ref.: Annex 9 of the  
Draft Regulation on AFS

Working Paper  
(non-approved)  
of  
the "ad-hoc Group on Rxxx-Annex 9"

REF.: DRAFT REGULATION NR.XXX , (WD 4-1)

PASSING BEAM "CUT-OFF" AND AIMING PROVISIONS

Figures A.9-1 through A.9-3

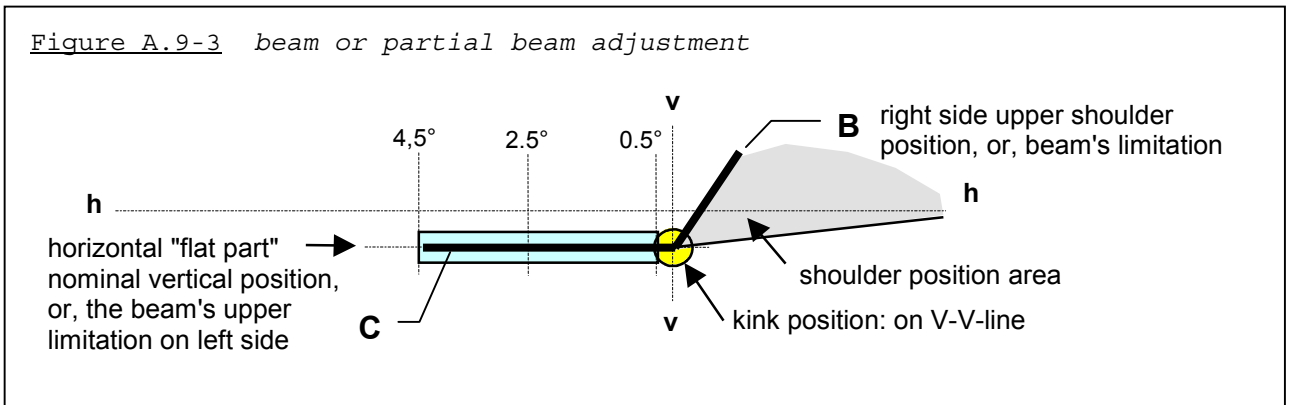
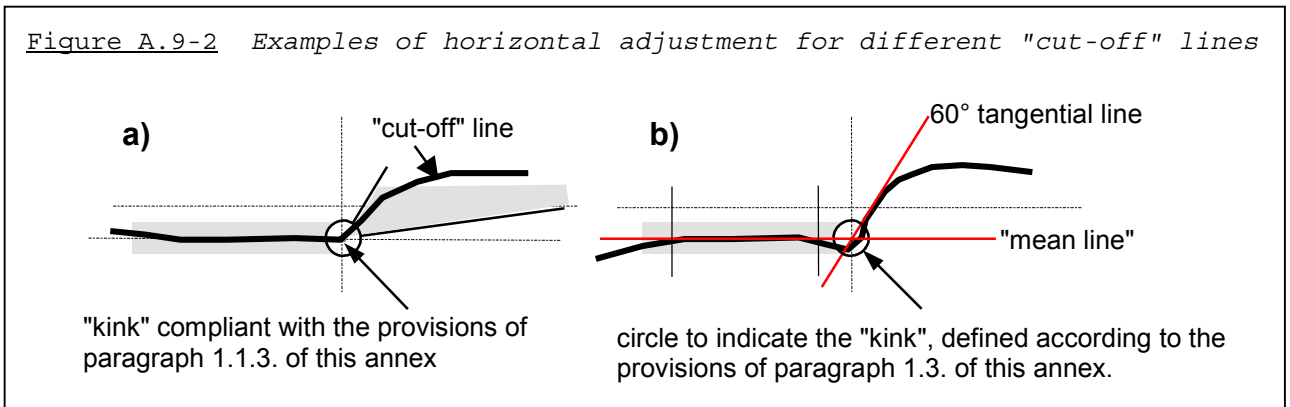
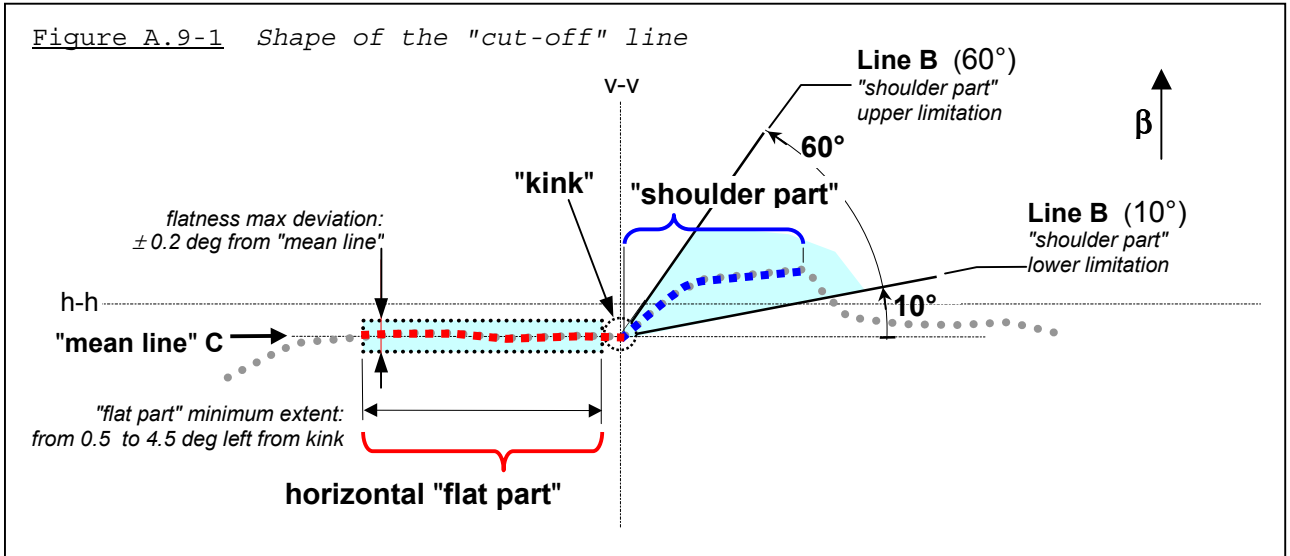
The graphs in the Figures A.9-1 through A.9-3 have been amended accordingly.

1.1.2. the "shoulder" shall extend only between the lines "A" and "B", as being defined in the graph of Fig. A.9-1 below;

1.1.3. The "kink" is the point where the horizontal "flat part" meets the "shoulder" part (see graph (a) of Fig. A.9-2 below);

considered to be the point of intersection of the extended horizontal "mean line" with a 60 deg tangential line to the **left side of the "shoulder"** as shown in graph (b) of Fig. A.9-2 below.

2.3.2.1. however, the beam shall be adjusted so, that its illuminating part does not extend beyond the line "B-C" as defined in the graph of Fig. A.9-1 below, and at the nominal vertical position (see Fig. A.9-3 below) according to the respective requirements indicated in Table 2 of annex 3. to this Regulation.

**Scheme of required cut-off**

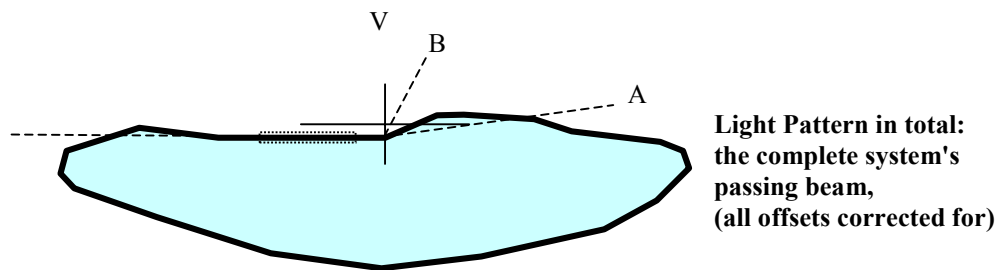
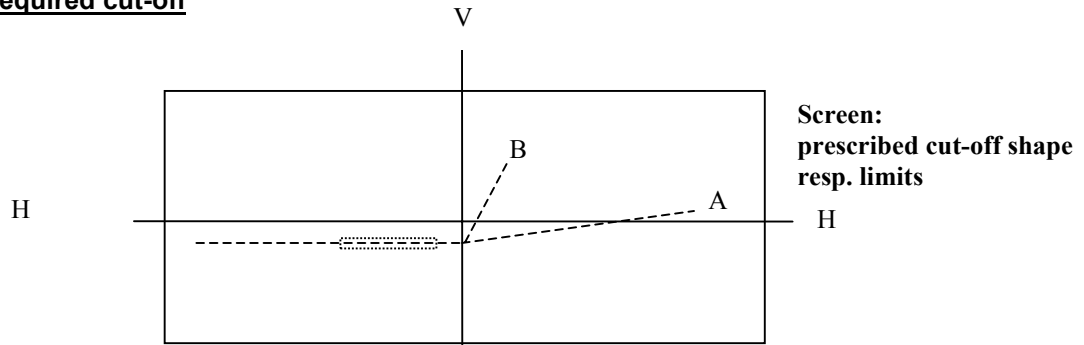
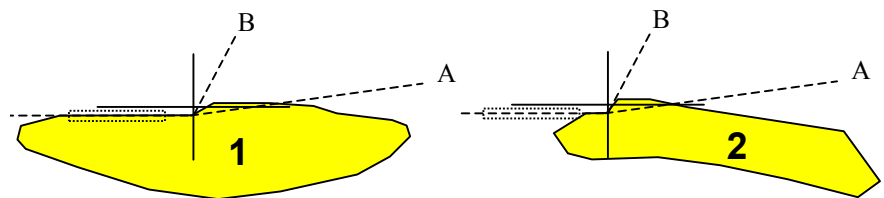
At the end of this working paper a schematical graph shows some examples of partial beam patterns for adaptive frontlighting and their cut-off characteristic and related aiming provisions.

vert. adjustment: para. 2.2.1.  
horiz. adjustment: para. 2.2.2.

vert. adjustment: para. 2.3.1.  
horiz. adjustment: para. 2.3.1.  
(applicants spec)

vert. adjustment: para. 2.3.2.  
horiz. adjustment: para. 2.3.2.  
(applicants spec)

pre-set by design
